REMARKS

Office Action Objections and Rejections Summary

FIGURE 1

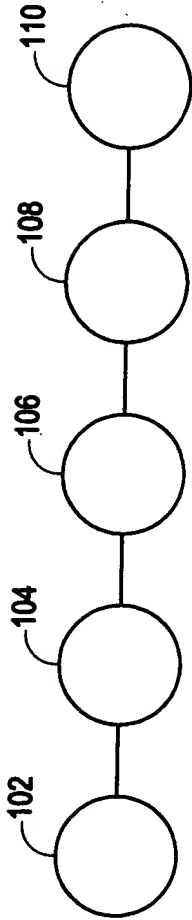
Examiner requests that **FIG. 1** and **FIG. 2** be designated by a legend such as –Prior Art-. Applicant has amended **FIG. 1** and **FIG. 2** accordingly. Attached hereto are replacement sheets and an additional set marked up in red ink indicating changes.

(Prior Art)
